MAGNETIC
RESONANCE
Open Access
Discussions

Interactive comment on "ArduiTaM: accurate and inexpensive NMR auto tune and match system" *by* Mazin Jouda et al.

Received and published: 23 May 2020

Fig. 1. Sample loading effect

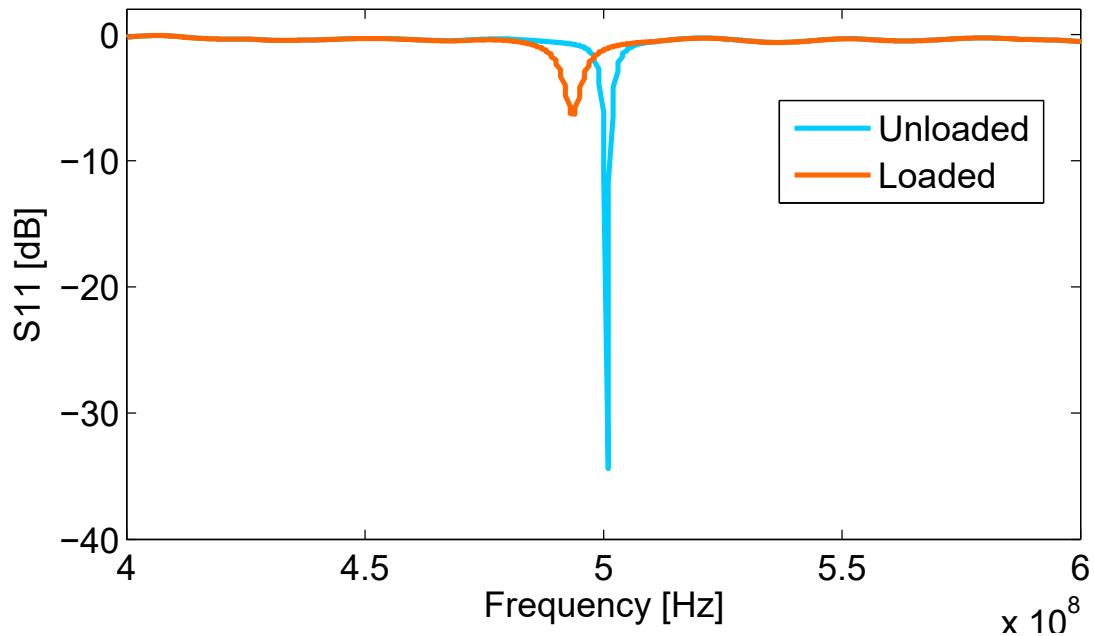
Reviewer: 2. Tuning and matching, in general, are performed after a sample is loaded.

If the shift by loading a sample s negligible, this work has less scientific impact. Also, RF coils that have a little bit wide bandwidth may resolve the loading problems. In this respect, the authors are required supplement ad- dition experiments to prove the necessity of this work. For example, bench test results with a universal tuning and matching before and after a sample loads to show loading effect that should be compensated. Also, the authors can add an image and SNR com- parison with a universal tuned and matched coil using a sample without manual and auto correction in figure 9.

Authors: As detailed in Hoult's paper (Hoult, D. I. (1979). Journal of Magnetic Resonance, 34, 425–433.) the sample-loading effect depends on many parameters including the coil geometry, coil parameters (R, L, C, Q), sample parameters, and the frequency of operation. To elaborate how large this effect can be, we did a couple of experiments and added two figures to the supplementary materials, which we also attach here as Fig 1 and Fig 2.

Figure 1: shows the unloaded/loaded S11 of a commercial 5 mm saddle coil designed to operate in a 11.7 T NMR magnet at 500 MHz. The sample we used was 0.5 M NaPO3, 0.5 M Phosphoric Buffer Solution (PBS), 50 mM TSP, and 0.5 MSucrose. Loading the sample showed a dramatic change (6 MHz frequency shift and 28 dB increase in the reflection) in the tuning and matching condition.
